Access Compliance Report

Public Rights-of-Way

Intersection ID: 27181	Main Street: MCKEE_RD	Cross Street: PROVIDENCE_PARK_DR	Location: NE
ADA ID: 5F7A5148E807	Ramp Type: Perp	Initial Pass/Fail: Fail	Overall Compliance: No
		Severity Score: 1.25

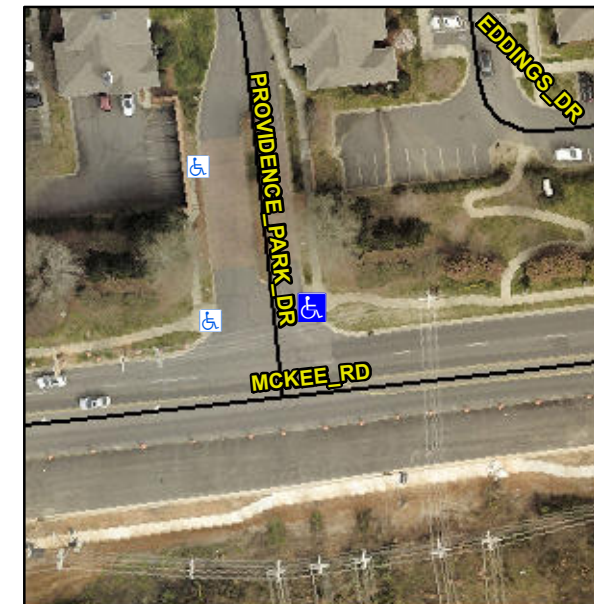
Not Found, R304.5.3

Compliance	Description	Data	Compliance	Description	Data
N/A	Ramp Length (in)	51.0	Yes	Ramp Slope (%)	8.2
Yes	Ramp Width (in)	62.0	No	Ramp XSlope (%)	4.0
N/A	Flare Type LT	N/A	N/A	Flare Type RT	N/A
N/A	Flare Slope LT (%)	N/A	N/A	Flare Slope RT (%)	N/A
N/A	Flare Traversable LT?	N/A	N/A	Flare Traversable RT?	N/A
N/A	Landing Length (in)	N/A	N/A	DWS Provided?	N/A
N/A	Landing Width (in)	N/A	N/A	DWS Contrast?	N/A
N/A	Landing Slope (%)	N/A	N/A	DWS Length (in)	N/A
N/A	Landing X Slope (%)	N/A	N/A	DWS Full Width?	N/A
N/A	Landing Curb? (Y/N)	N/A	N/A	DWS Offset (in)	N/A
N/A	Shared Landing?	N/A			
N/A	Gutter Ponding?	N/A	N/A	Gutter Slope (%)	N/A
N/A	Gutter Lip Ht (in)	N/A	N/A	Gutter X Slope (%)	N/A
N/A	Painted X Walk1?	No	N/A	Painted X Walk2?	N/A
	X Walk 1 Direction	To W		X Walk 2 Direction	N/A
N/A	X Walk 1 Width (in)	N/A	N/A	X Walk 2 Width (in)	N/A
	X Walk 1 Slope (%)	1.4		X Walk 2 Slope (%)	N/A
	X Walk 1 X Slope (%)	5.2		X Walk 2 X Slope (%)	N/A

Remove & Replace Entire Ramp.
